RE: 204-210 Parramatta Road, Auburn, NSW 2144 – Facts and Contentions

In response to the Statement of Facts and Contentions (case no: 2022/00175835) raised by Cumberland City Council, Meinhardt Group has been engaged by Skematics to address all stormwater contentions identified in Part B – Contentions. The stormwater contentions raised by Council have been outlined below with responses provide by Meinhardt Group.

DESIGNED	DRAWN	APPROVED	DATE	SCALE @A1	SHEET
TD	TD	LM	22.01.20	AS SHOWN	OF
PROJECT No 121465		DRAWING No C740		REV P04

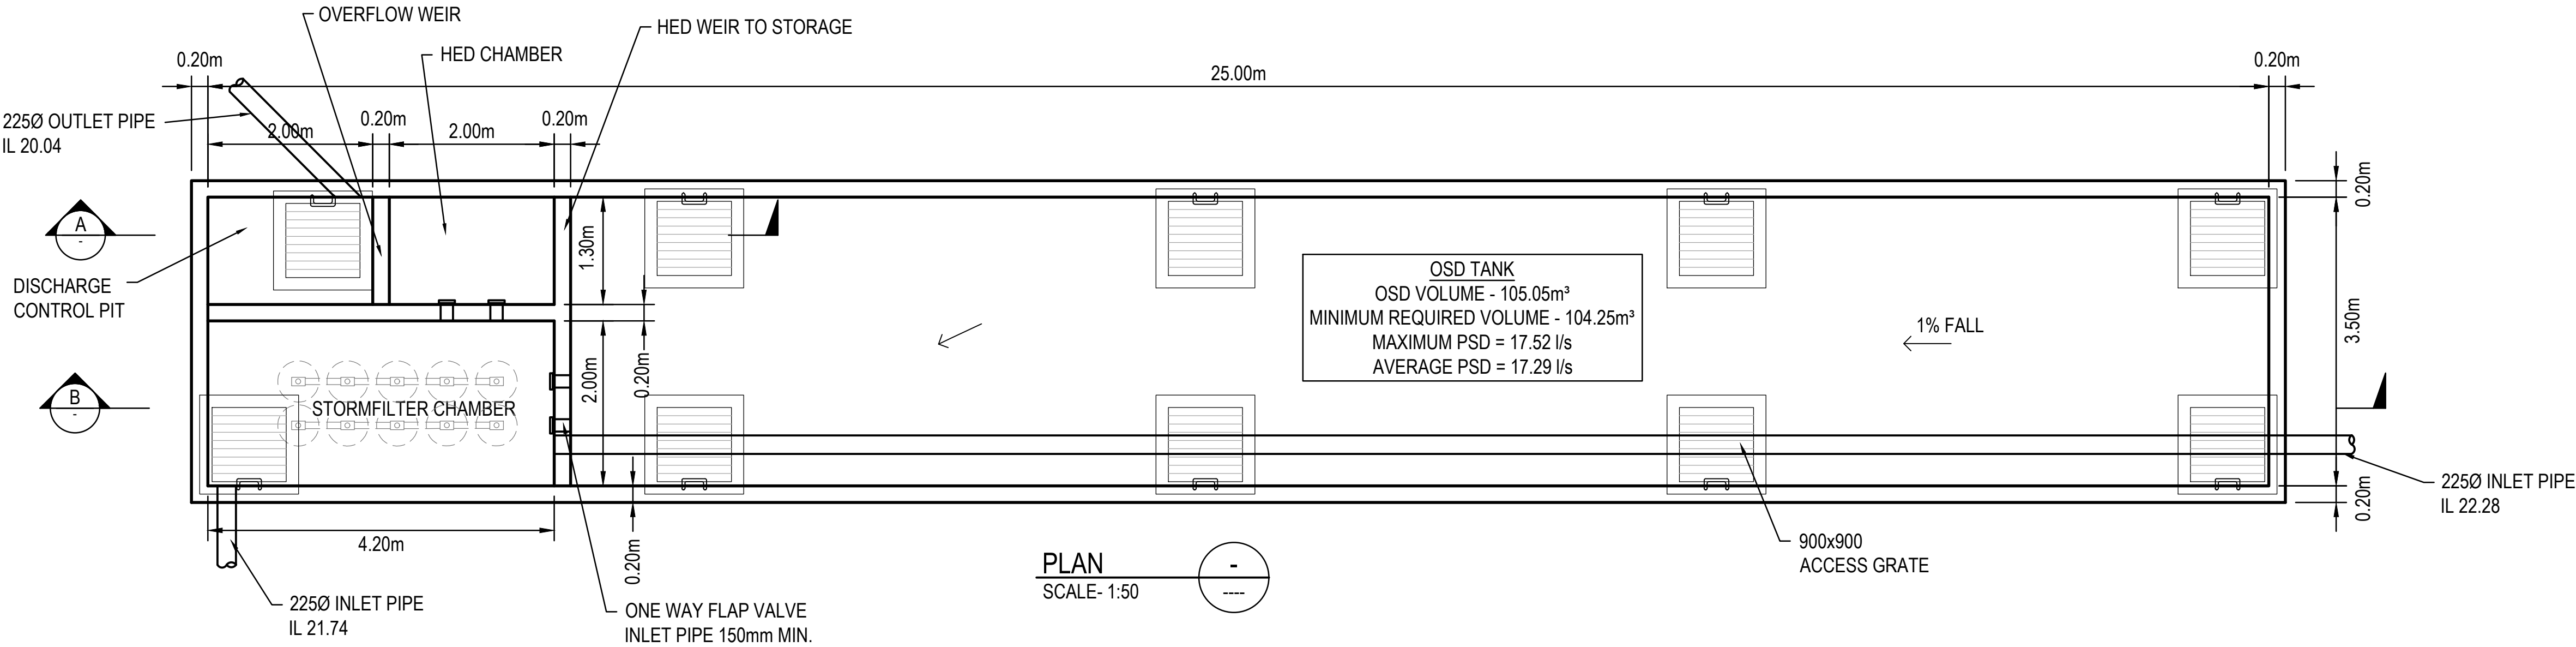
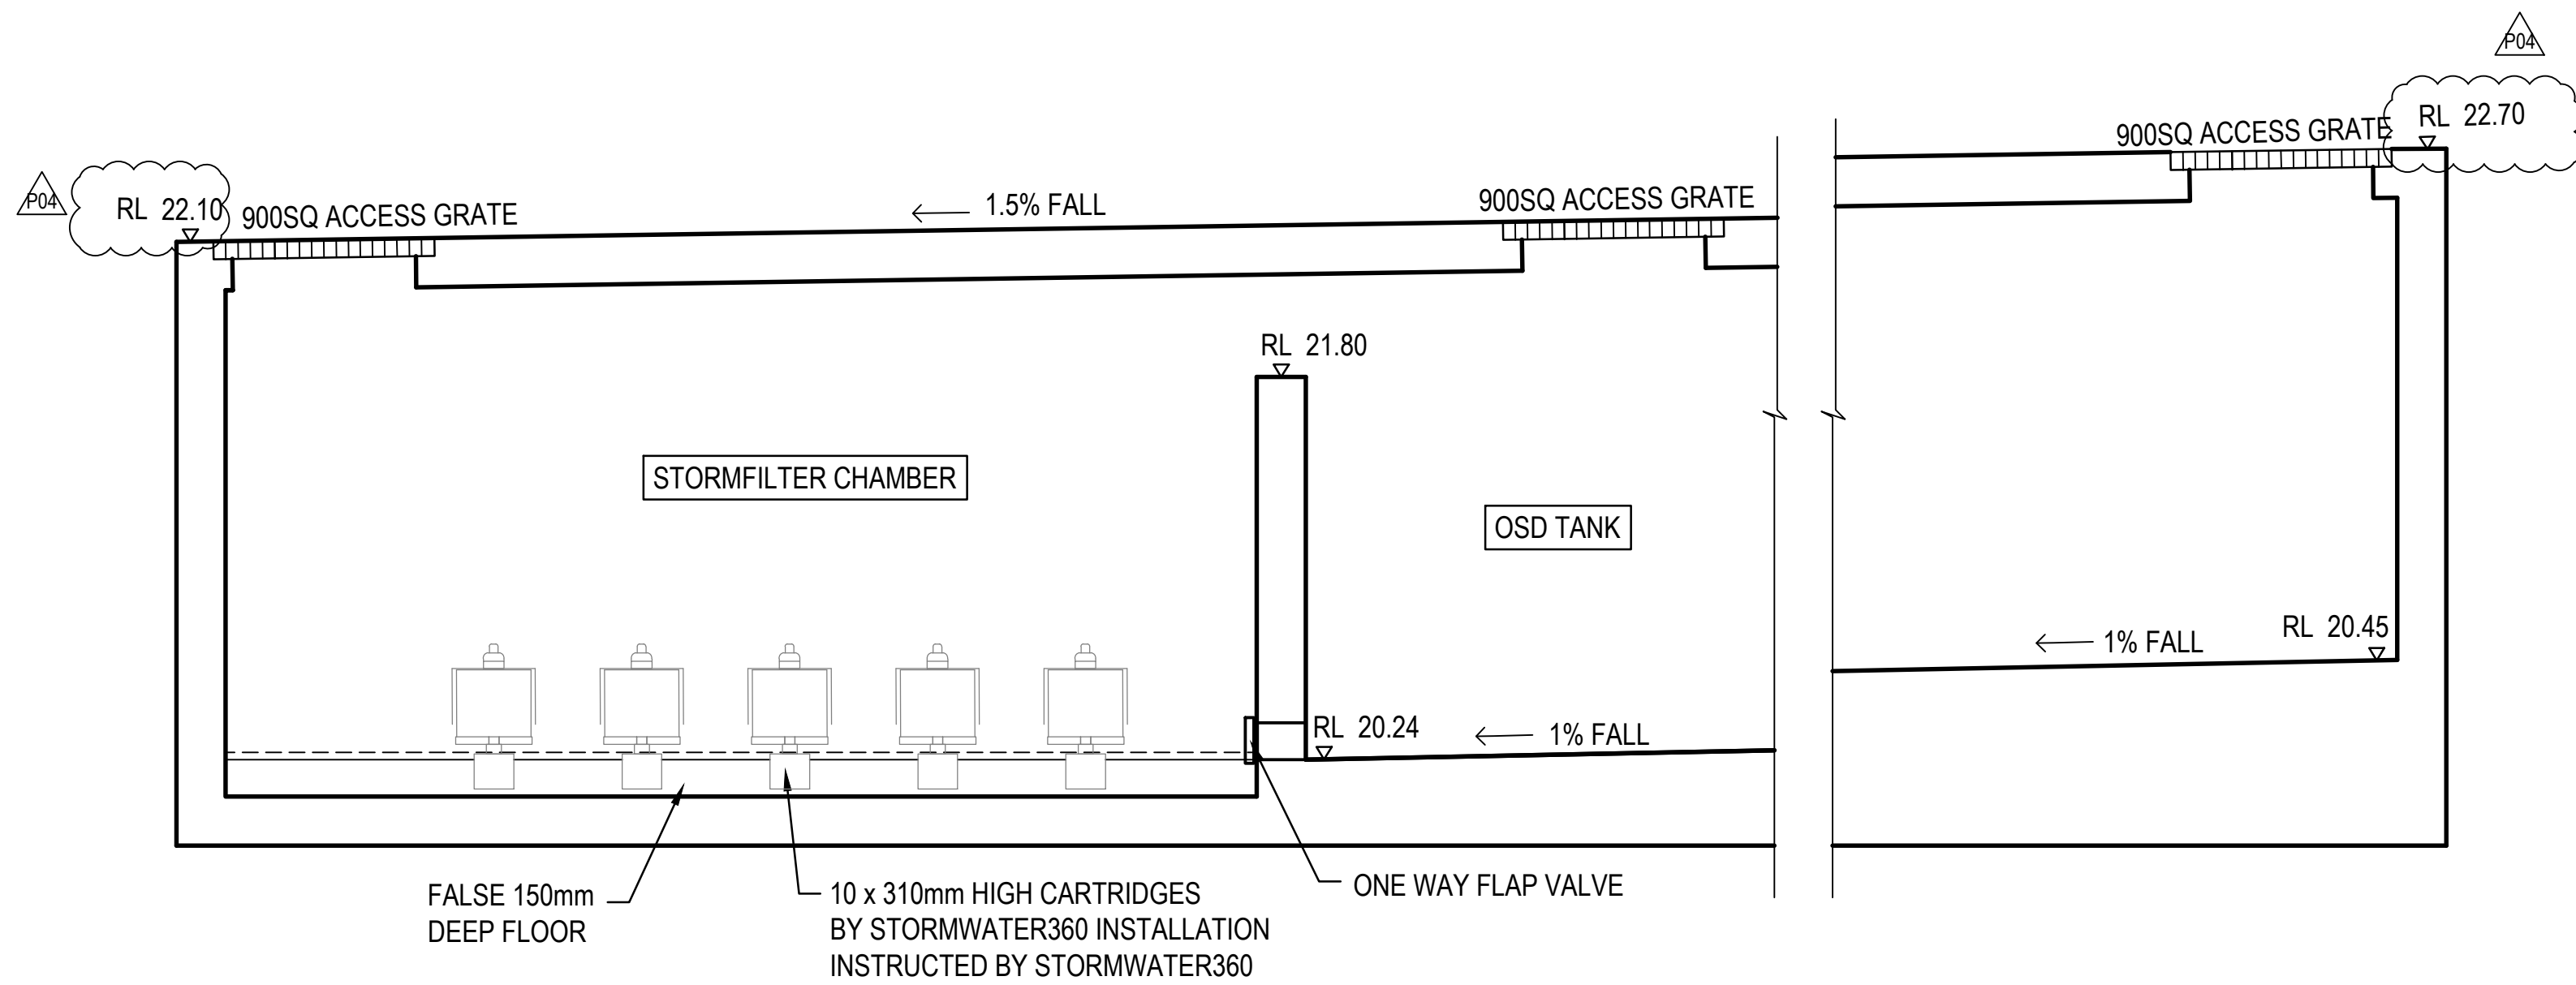
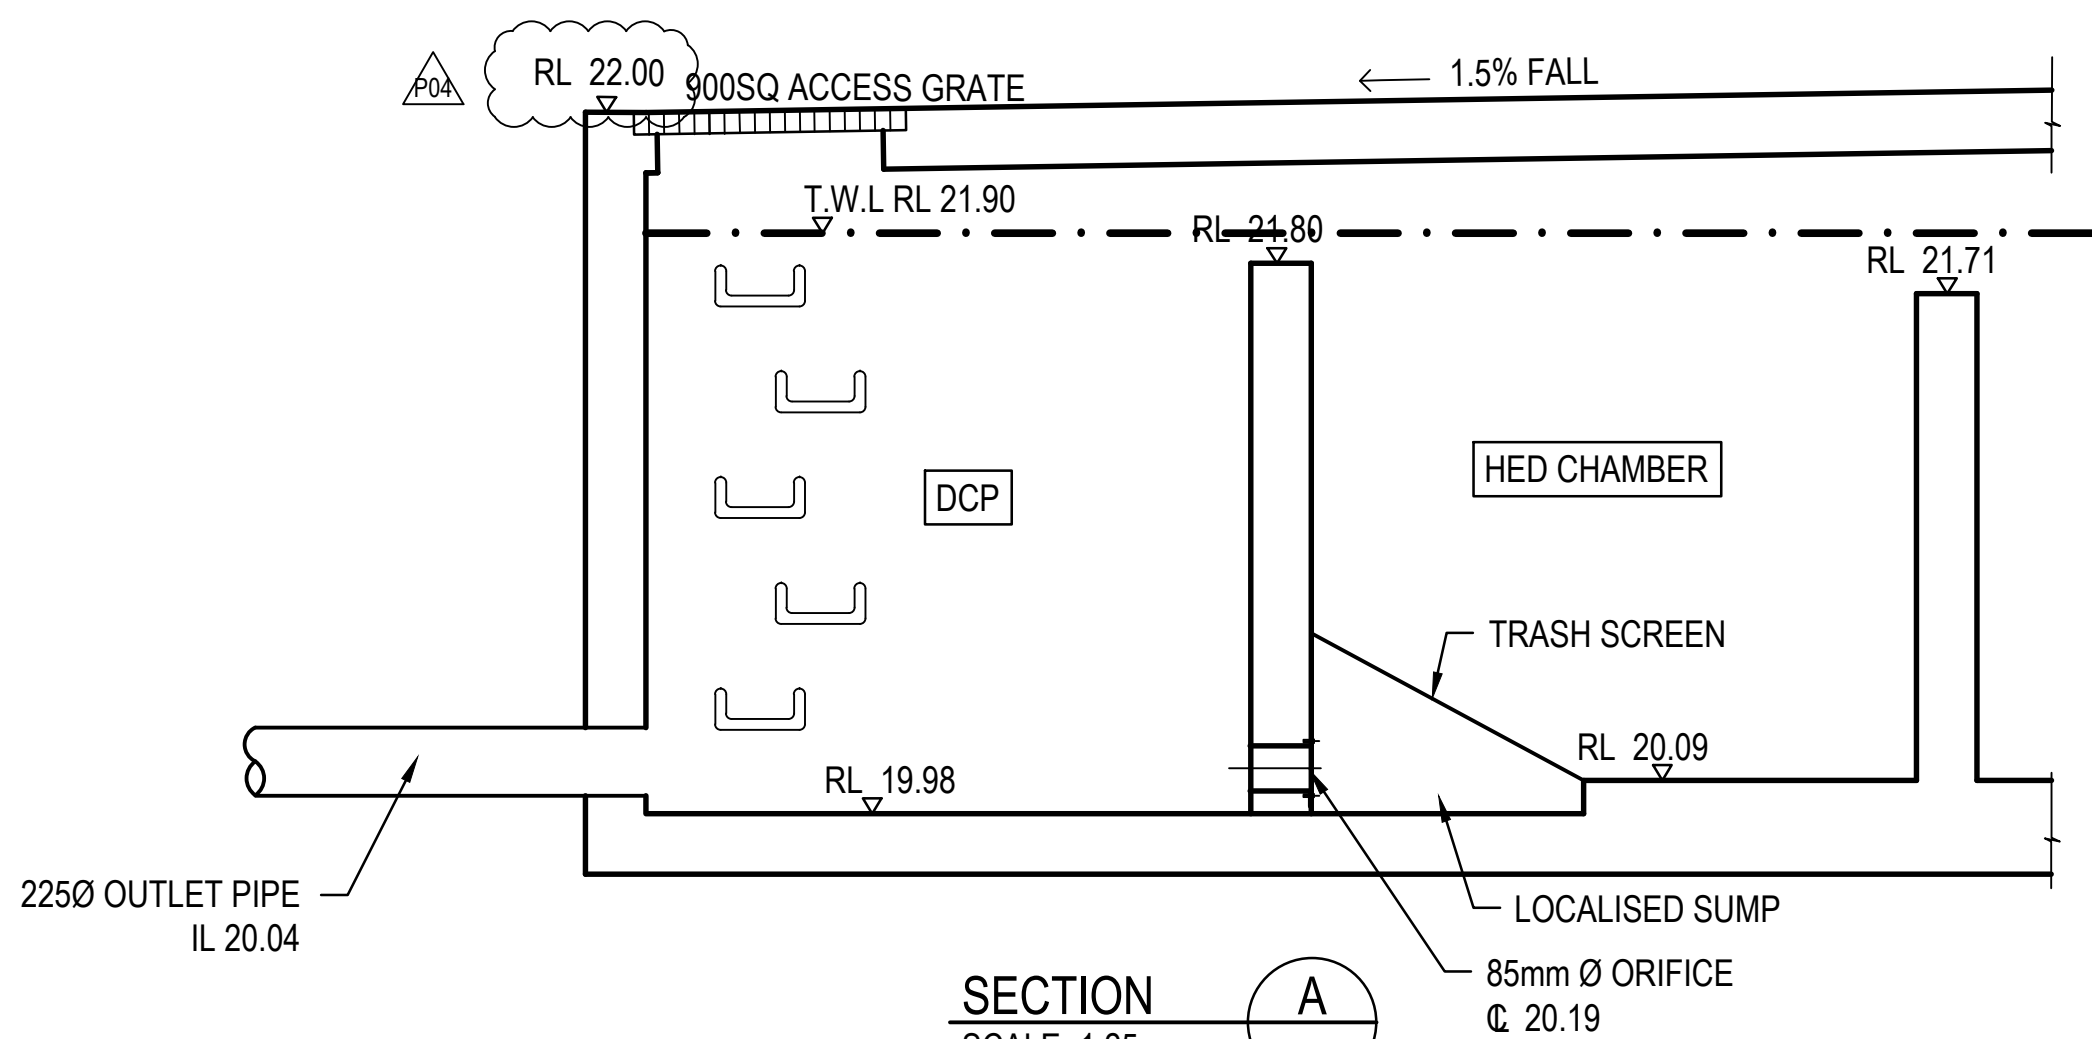
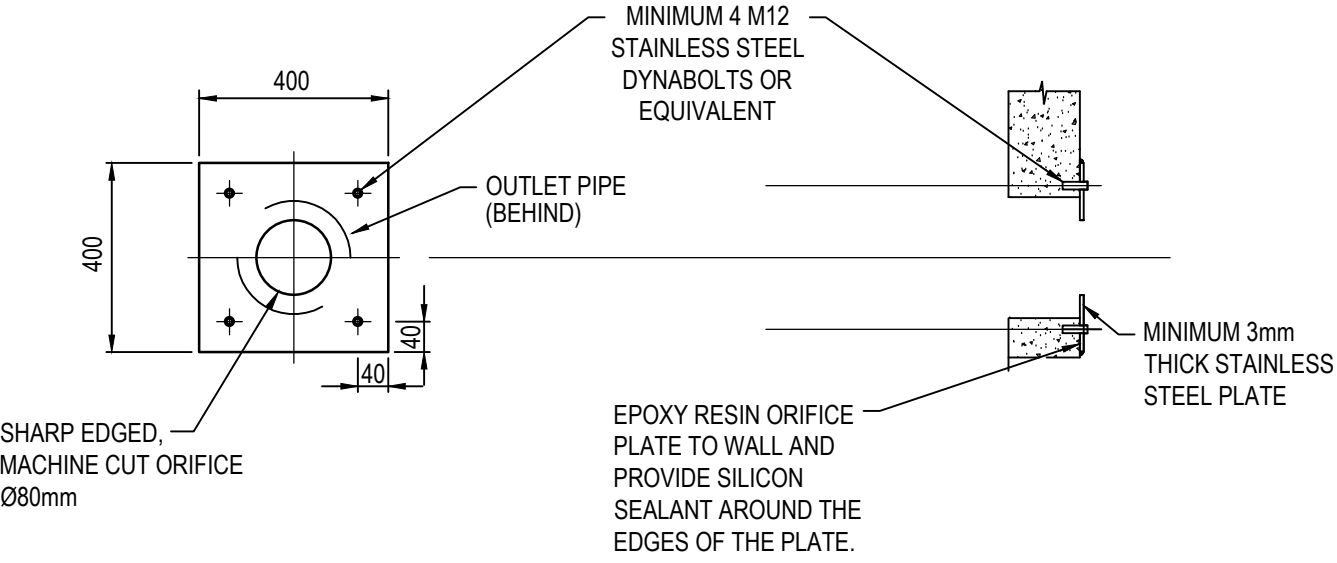
- (c) The development has not designed the on-site detention system as a submerged outlet. The orifice outlet should be designed to function as a submerged outlet, with submerged conditions to be reflected in the on site detention (OSD) calculations. OSD should be provided in accordance with the Stormwater Drainage Part G4 of the Cumberland Development Control Plan 2021 and the Upper Parramatta River Catchment Trust "On-Site Detention Handbook" (Third edition).

Based on the following engineering information below, we believe the OSD should not be modelled with a submerged outlet.

- A hydraulic assessment using DRAINS has been undertaken for the proposed stormwater network in Braemar Avenue. The assessment has modelled the 1% AEP stormwater event and considered all upstream and downstream catchments. The catchments have been delineated using QGIS with the latest Digital Elevation Model (DEM) and can be seen on drawing sheet C800 – Catchment Management Plan. Furthermore, the assessment has assumed a tailwater level of 18.42m (150mm below the surface level) at the existing pit (ID 5/15SP018506). Based on this assessment, the hydraulic grade line at the proposed kerb inlet pit adjacent to the subject site is 20.08m AHD. The centre line level of the orifice in the OSD is 20.19m AHD. **This assessment has shown that the OSD will not operate under a submerged outlet scenario.**

- The outlet pipe from the OSD has been sized to prevent submergence.
- The **subject site is located at the top of the local catchment area** therefore is less likely to be impacted by downstream tailwater conditions. Refer to drawing sheet C800 – Catchment Management Plan
